BOURNS® Product Update Memo

March, 2006

Model 3362 Knob Addition

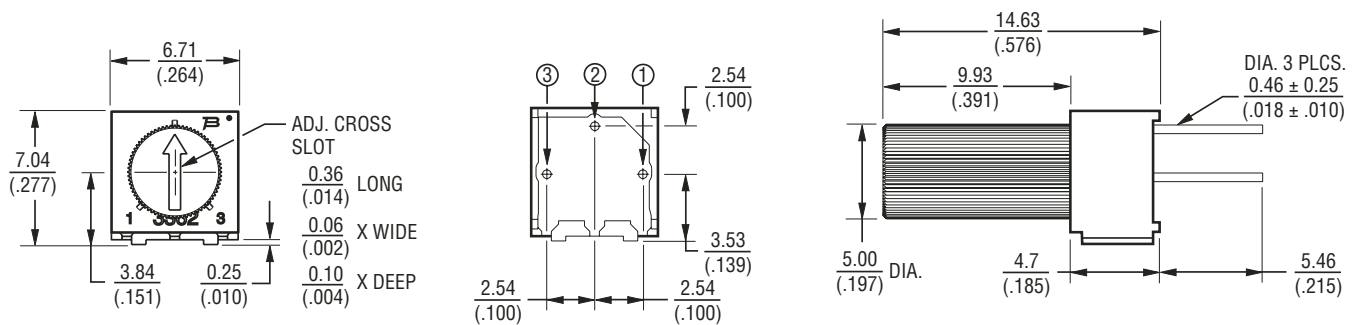
Bourns® Trimpot® Division is proud to announce the addition of a knob option to the [Model 3362](#). The knob option is currently only available in the top adjust versions. Side adjust versions can be made available, but will require a NRE charge.

The knob option is available as standard and RoHS compliant product. The RoHS version requires the addition of an LF suffix.

Standard: 3362 Knob – 3362P-1-103T

RoHS: 3362 Knob – 3362P-1-103TLF
